LU 2021-023 SUB Cedar Creek Gardens

Week 2 Rebuttal Period

Exhibit C – Public Testimony

Addendum to Sweeney Argument #1

#14

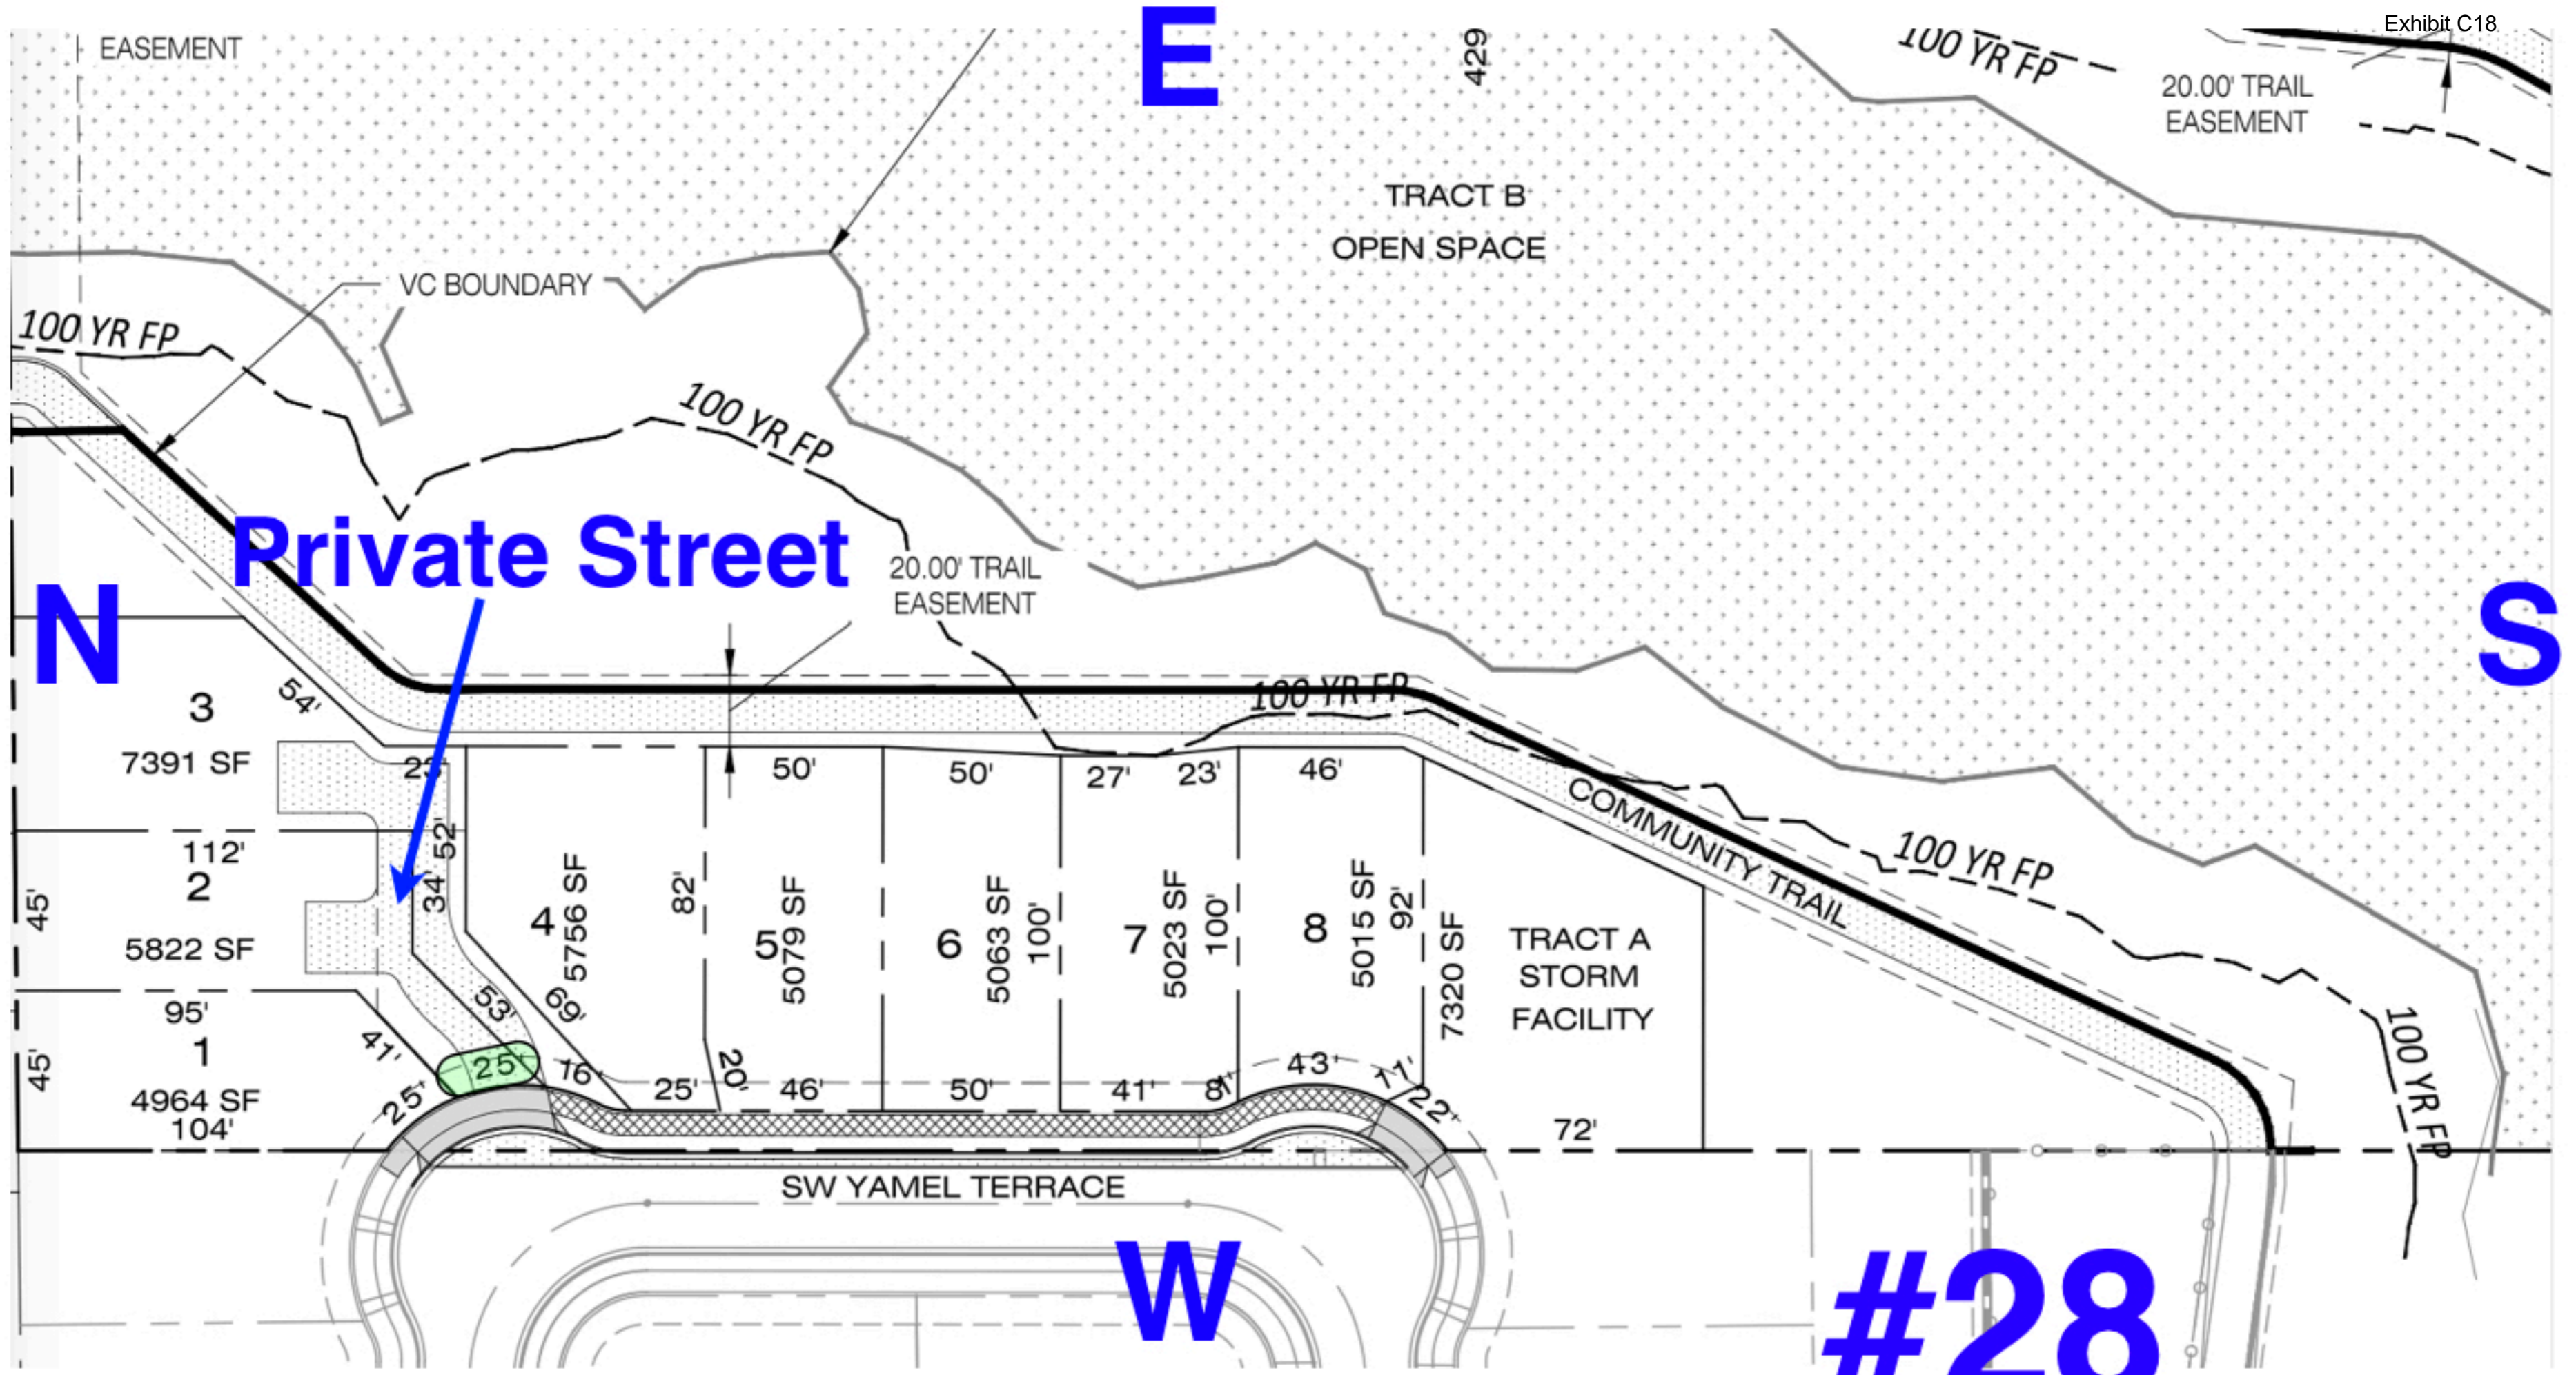
The addendum to this argument comes in the form of supportive information (aka Maps #s 5, 7, 14, & 28). All four are of a twenty (20) foot width of a private street. Map #7 the 20 foot width of the private street serving lots 19 & 20, Map #14 the 20 foot width for private street serving lot 39. Map #28 serving the private street for lots 2 & 3 is not *exactly* labeled as 20 feet in width but *is* labeled with something a little less than 25 feet (see green blob to the right of lot #1). And map #5 showing the shared driveway serving lots 40 & 41 only 12 feet wide.

Since three of the private streets (serving lots 2 & 3, 19 & 20, and 39) are 20 feet in width it supports the 20 foot wide shared driveway for two families and lots 40 & 41 and Section 16.96.020.A.2. of the Code:

Figure 1: Sight Lines for Northbound Approach to Proposed Site Driveway

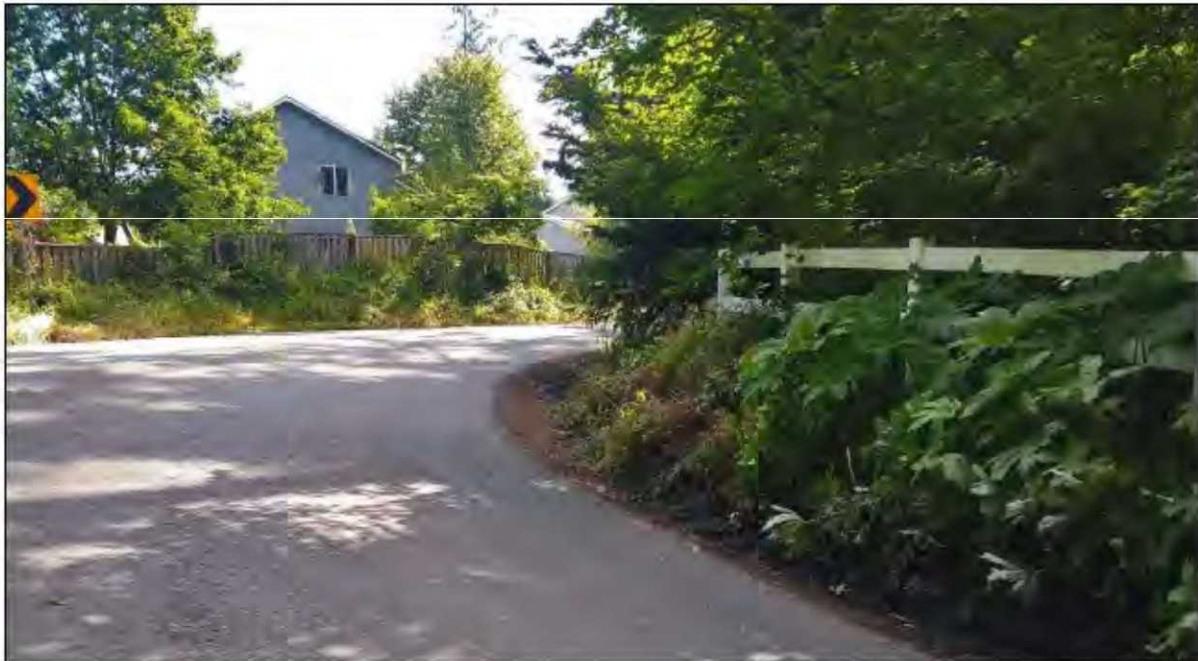
travel lanes, and trim trees on the inside curve to establish a minimum 155-foot clear sight distance. Side note: this sight distance does not meet Washington County standards however the County Engineer has accepted the distance as an alternative based on the use of AASHTO standards.

It is important to note that provided sketch illustrating the proposed turn and sight distance was prepared prior to the shift of proposed private street location 5-feet south for tree retention. That shift will increase the difficulty to provide the required sight distance. In addition, I have reviewed the proposed trimming of trees with the property owner, Buzz & Bonnie Wright, located at 16450 SW Brookman Road, and they have expressed concern that the proposed trimming will damage trees on their property. Complicating the issue is the fact that the property south and east of Brookman Road is located in Clackamas County, not Washington County.

To obtain the needed stopping sight distance of 155 feet, several improvements will be required as shown in Figure 2. These improvements include:

- Increasing the corner radius by widening the roadway to the west and north and restriping the travel lanes. This improvement will shift the turning vehicle to the west and increase the available sight lines.
- Clearing the sight triangle by pruning overhanging tree branches along the fence of the southeast property and restricting the height of the ground cover growing along the shoulder.
